**CALIFORNIA REGIONAL WATER QUALITY CONTROL BOARD
LAHONTAN REGION**

**SUBJECT: REVISED WASTE DISCHARGE REQUIREMENTS - ROSAMOND
COMMUNITY SERVICES DISTRICT, DOMESTIC WASTEWATER
TREATMENT FACILITY / RECLAMATION PLANT, KERN
COUNTY**

The District’s consultant submitted comments on the tentative order (Enclosure 2) and staff responses are provided (Enclosure 3). Minor changes were made to the proposed order.

Figure 2: RWWTP Facilities and Wells near the Site

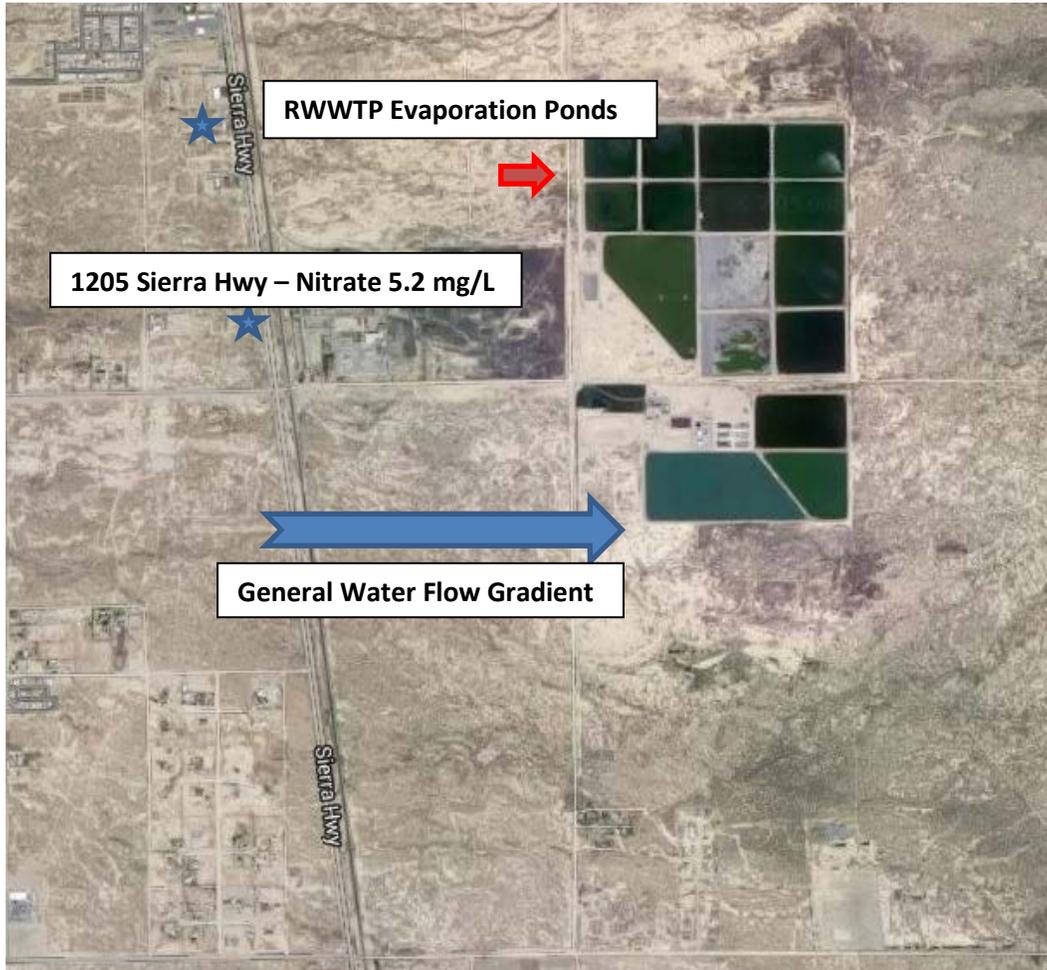
In response to Lahontan RWQCB's letter dated September 4, 2015, regarding the subject Tentative Revised WDR RCSD has reviewed and provided comments. Comments are being submitted prior to the October 4, 2015 deadline, as requested. Enclosed you will find a pdf which includes the draft WDR with comments, the comments in table format, and supporting figures. Figure 1 is being presented to establish the general location of the RWWTP in relation to the location of the Rosamond Dry Lake. This is being presented to facilitate the discussion regarding potential sources of influence and potential wq impacts. Figure 2 illustrates the location of RWWTP in relation to one of the nearby water supply wells. Also noted in this figure is the general groundwater flow direction and wq result for the well.
